VALUE ENGINEERING PROPOSAL

PROPOSAL NO:	S-5	PAGE NO:	1 OF 5
DESCRIPTION	Eliminate Dewatered Condition From Lock Design and Use T-Wall Design With Struts

DRAWING NO. 1

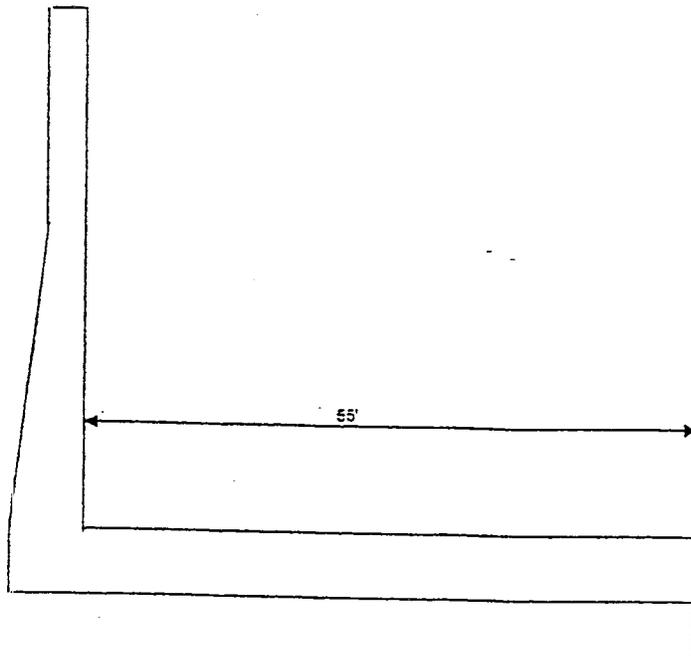
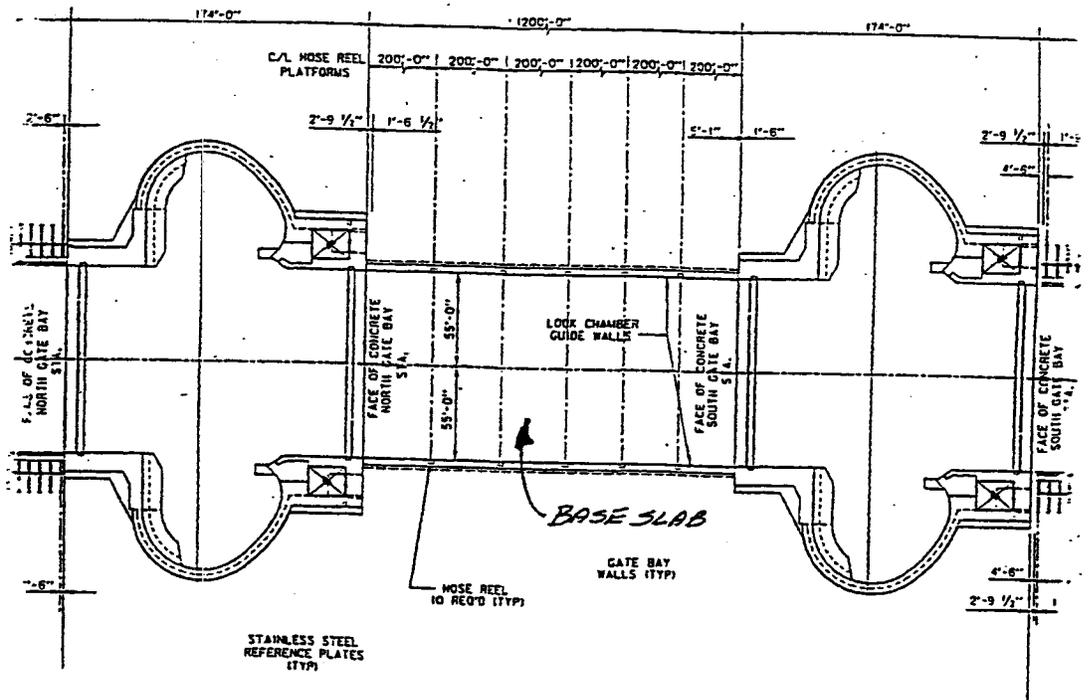
The existing lock design is a pile founded U-Frame structure. The U-Frame is designed for all loading conditions including the dewatered condition. The primary reason for lock dewatering is to allow inspection of the concrete surface and to perform repairs in the dry. The necessity for inspection of concrete surfaces is more critical for lock chambers that contain filling and emptying systems than those that do not. The added expense for a dewatered condition is additional piles that resist uplift forces and additional piles at the upstream and downstream bulkhead monoliths to resist the unbalanced lateral load. (See Drawing No 1)

It is proposed that the capability to dewater be eliminated. With the dewatering condition eliminated, it is no longer to construct a U-Frame to provide a seepage resistant chamber. Delete the floor slab and use a structure consisting of two T-Walls connected by struts that are articulated at the juncture with the T-Walls so that moment is not transferred. The T-Walls would be designed to resist gravity and overturning forces while the struts would carry the horizontal loads. The resulting foundation would use vertical piles since the horizontal loads would be transferred to the opposite wall through the struts. The backfill elevation has been designed so that the lateral force from the condition in which the water elevation in the lock is greater than that outside the lock is approximately equal. Therefore, the struts are only in compression. It is estimated that the base of the T-Wall would be about 2/3 of the wall height, about 35 feet. And the struts would be the same thickness as the chamber slab, approximately square and spaced at 100-foot intervals. (See Drawing No 2)
